# **CLARKSTON CITY HALL ANNEX RENOVATION OF MORRIS FAMILY HOUSE**

**CITY MANAGERS PROGRESS REPORT #7**

**PUNCH LIST PREPARED BY PROJECT ENGINEER AND ARCHITECT**

PROJECT: Clarkston City Hall Annex (Morris House), BA# 2012-04  
DATE: May 13, 2013

**Figure 306.3**  
**Knee Clearance**

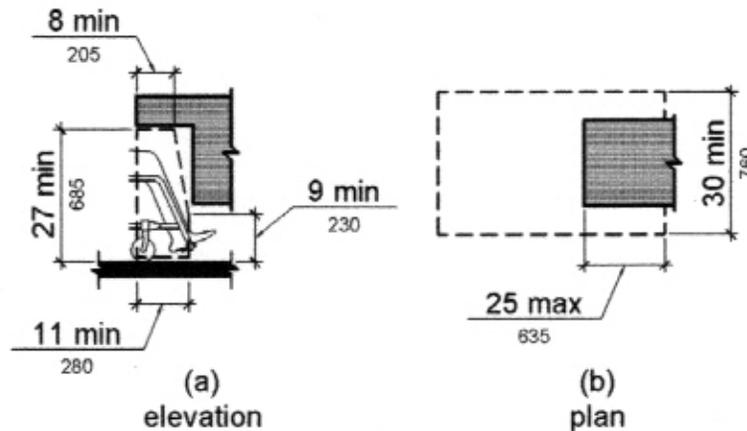
- F. Angled skirt board installed at Break Room sink does not meet the clearance requirements of ADA; see attached Section 306.3 Knee Clearance for dimensional requirements under accessible sinks. If skirt needs to be removed to provide accessibility, install protective wrap at under-sink piping.

FRONT HALL  
102

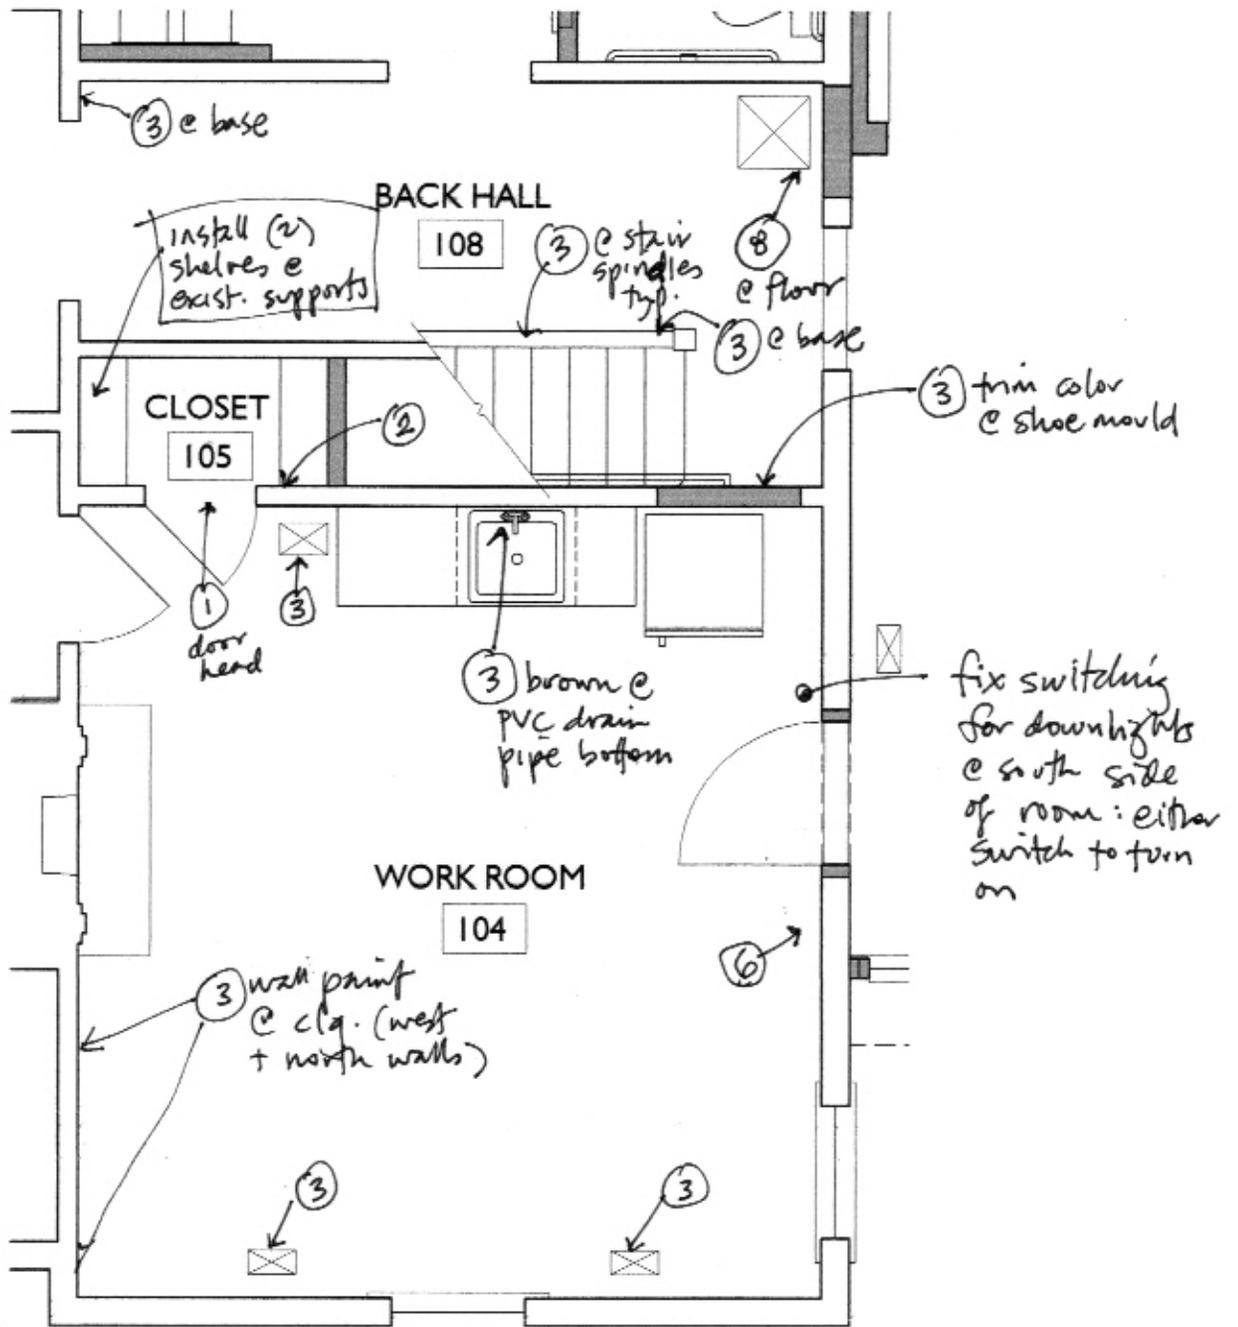
Front door:  
• sealant @ gaps

① @ top hinge  
② @ bottom hinge

③ @ side of door casing

③

③  
③

①  
⑤

④  
③  
floor

INSTALL DIMMER SWITCH FOR LIGHT

① sill

CONFERENCE  
103

install data outlet @ floor

black @ brick

patch hole @ hearth + ③

EAST ELEVATION

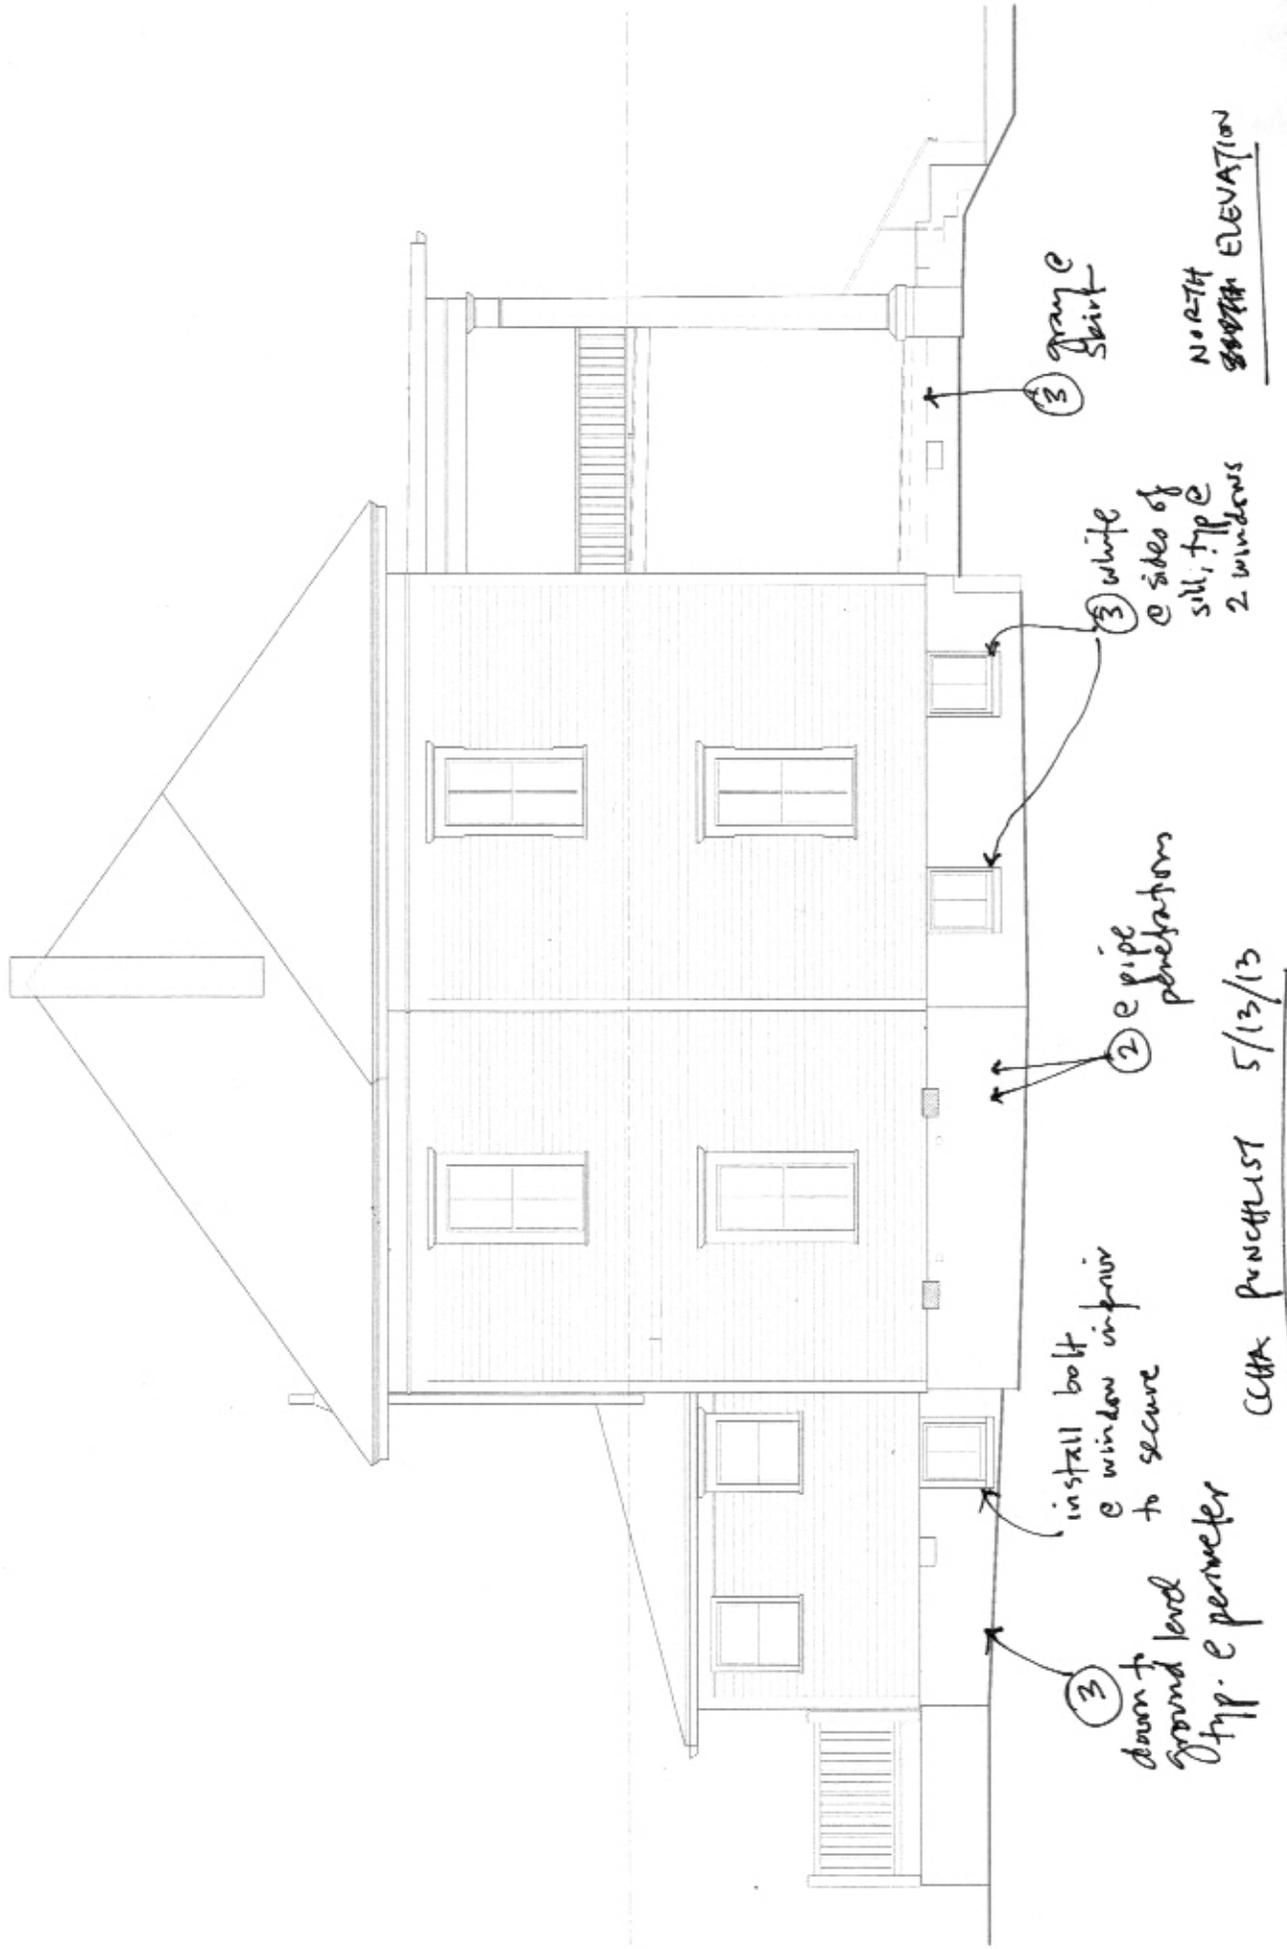
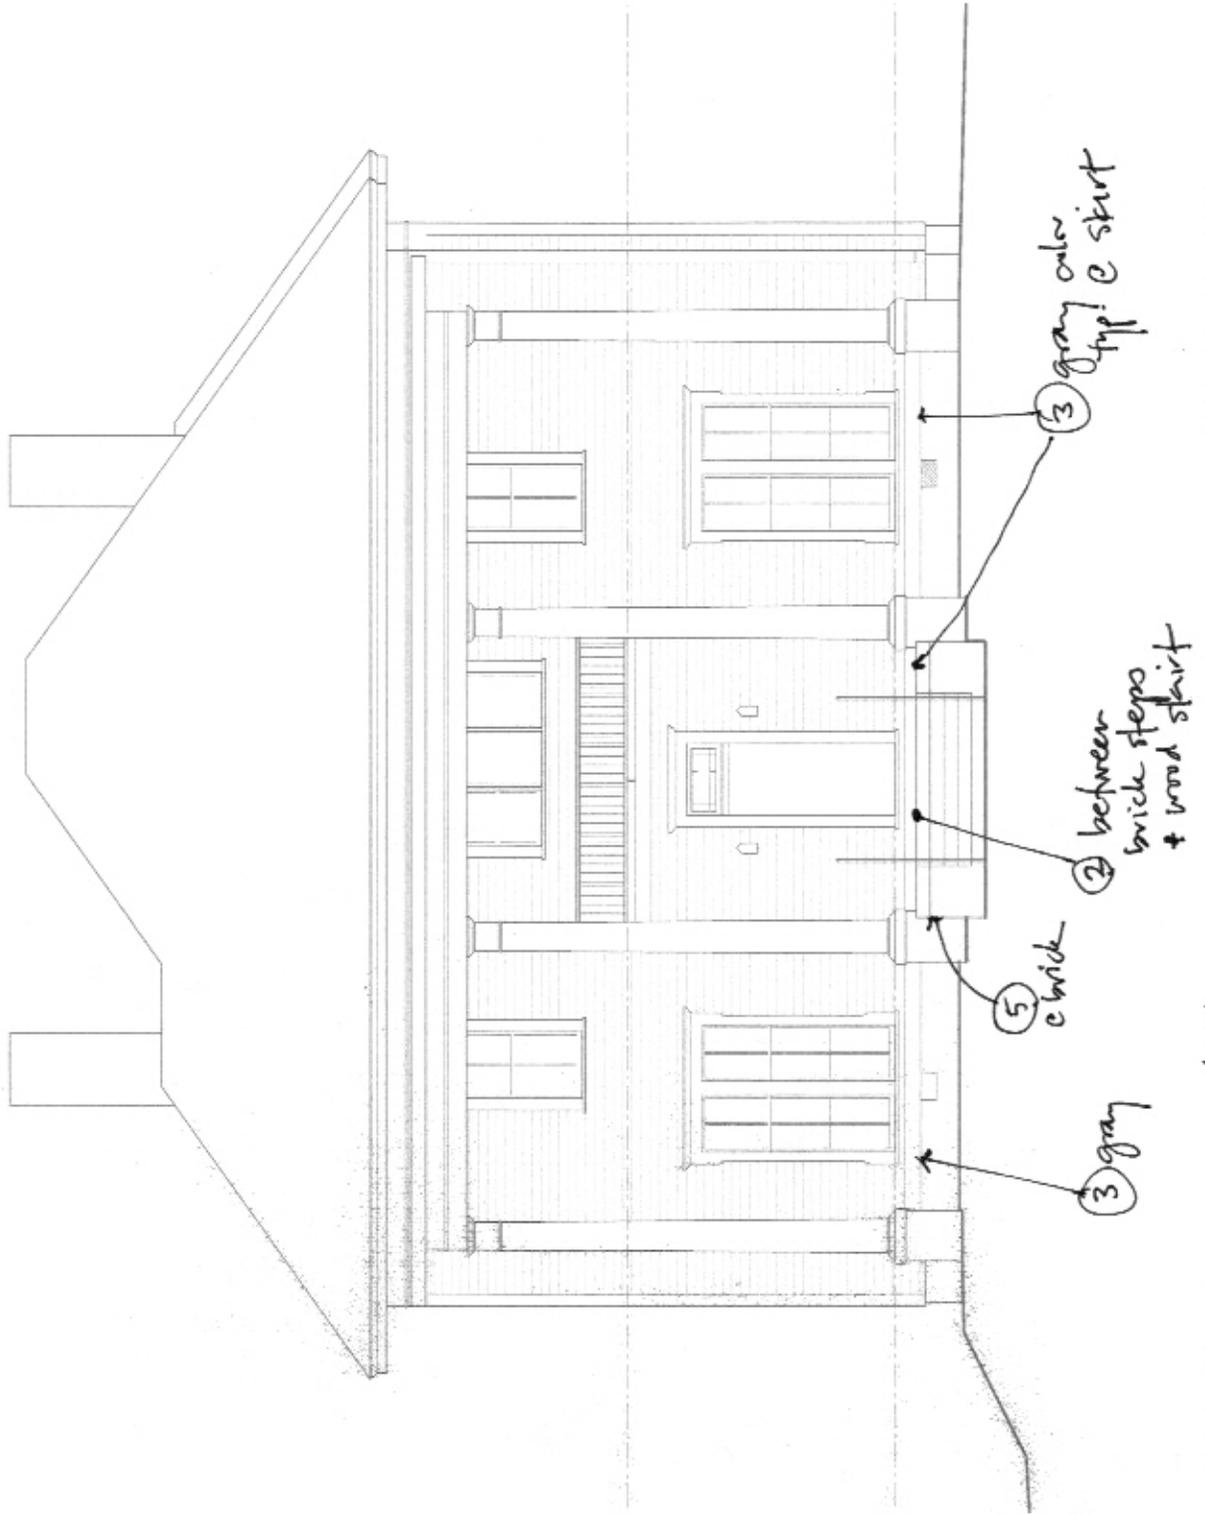
2<sup>nd</sup> Floor Balcony

WEST ELEVATION

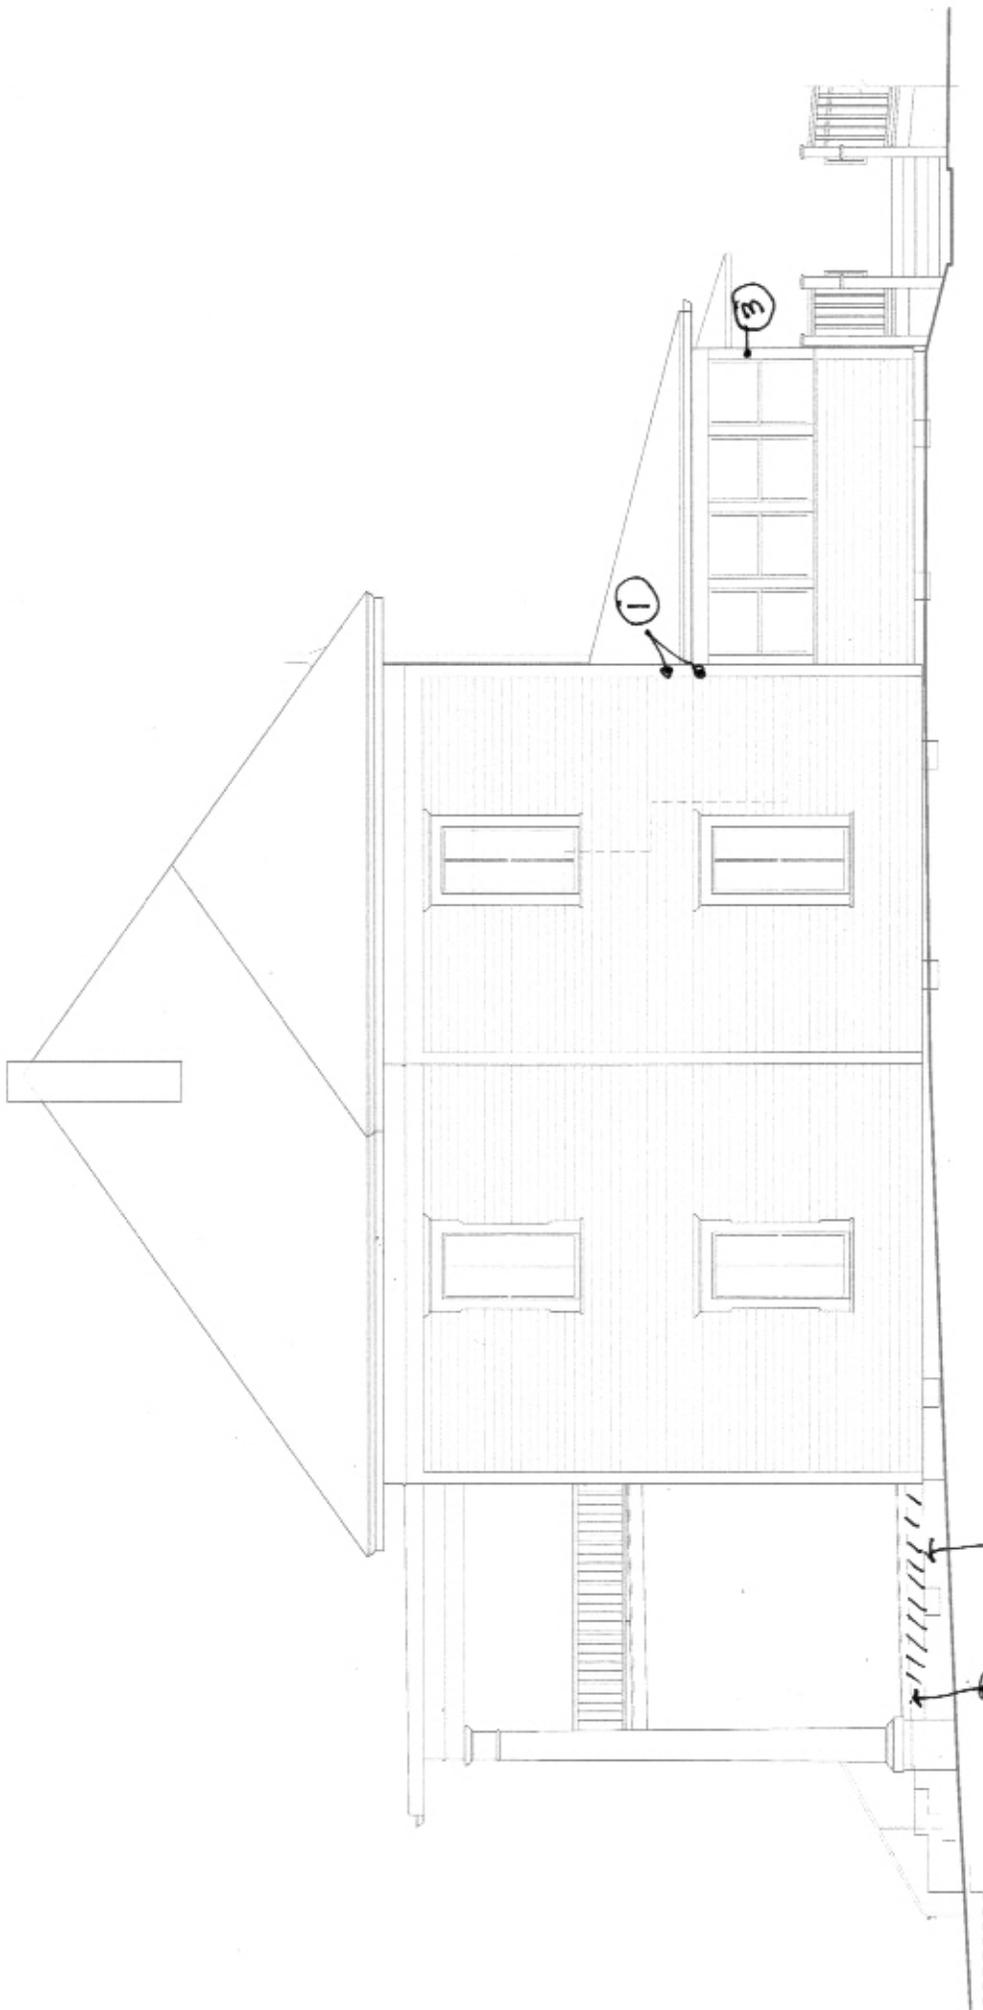
3 gray color  
@ skirt, top.
